Planning Commission Staff Report

MEETING DATE: JUNE 3, 2020

SUBJECT: DR20-47, BUSHTEX

To allow for the expansion of an existing satellite transmission company.

MEET TITLE
EXTERIOR
ELEVATIONS

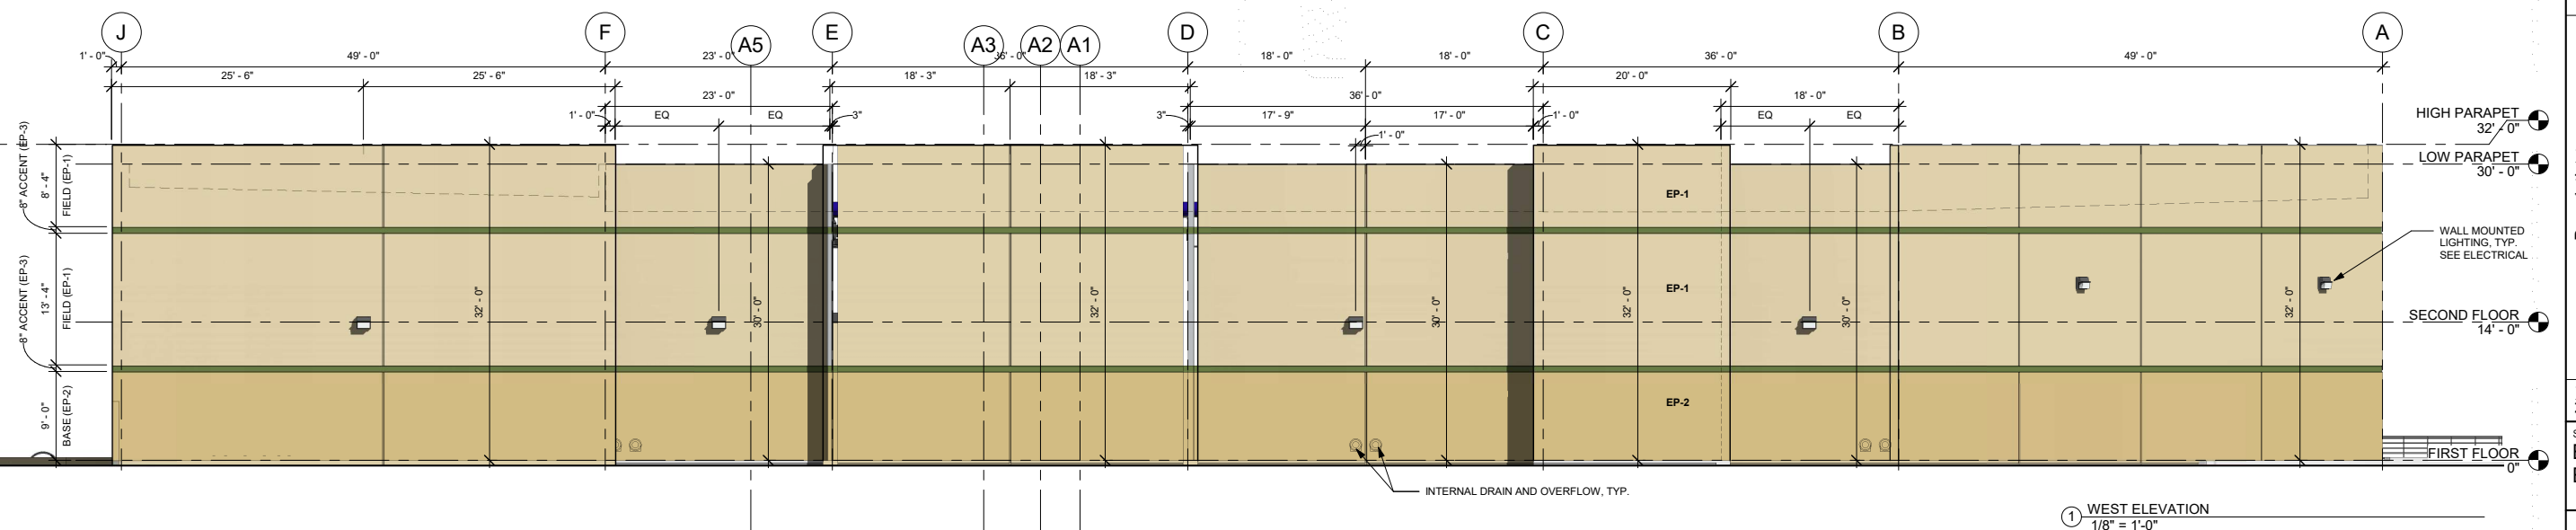
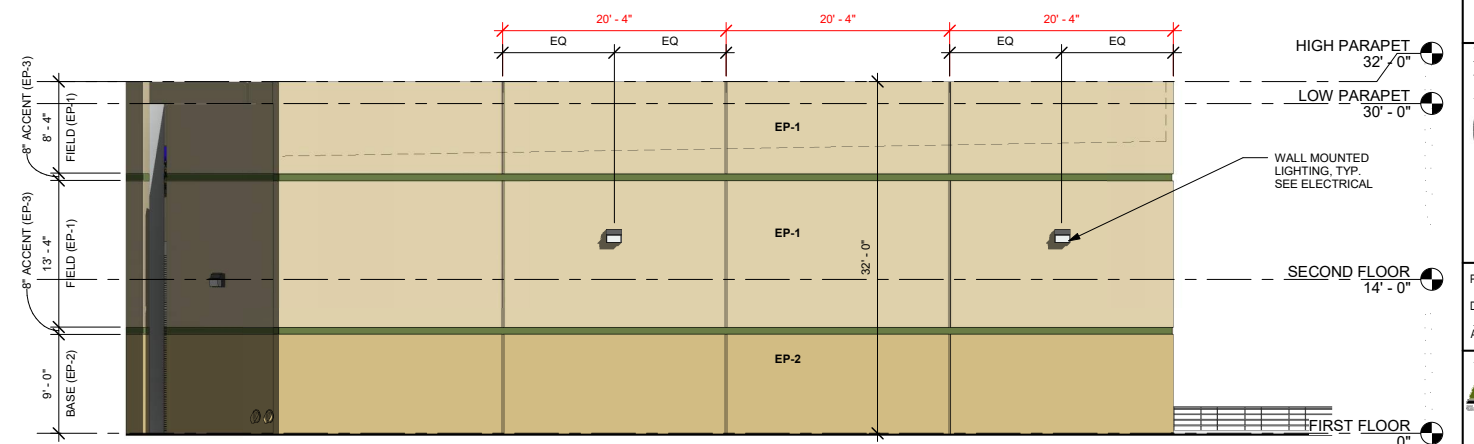
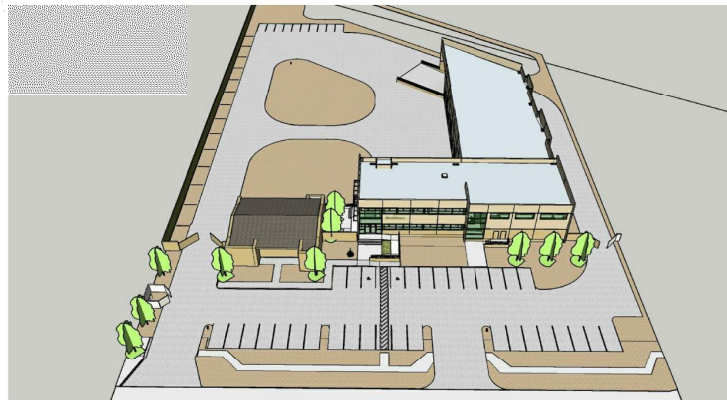
- Commissioners appreciated the new expansion in the area and felt it was an upgrade but the south facing wall could have some further articulation.
 - The applicant has revised the elevations to reflect the color blocking and the building will have 8" horizontal green bands and canopies to help with proportions and articulation. The south elevation was revised to include

canopies over the windows and the updates to the southwest elevation show that articulation is provided at the rear of the building.
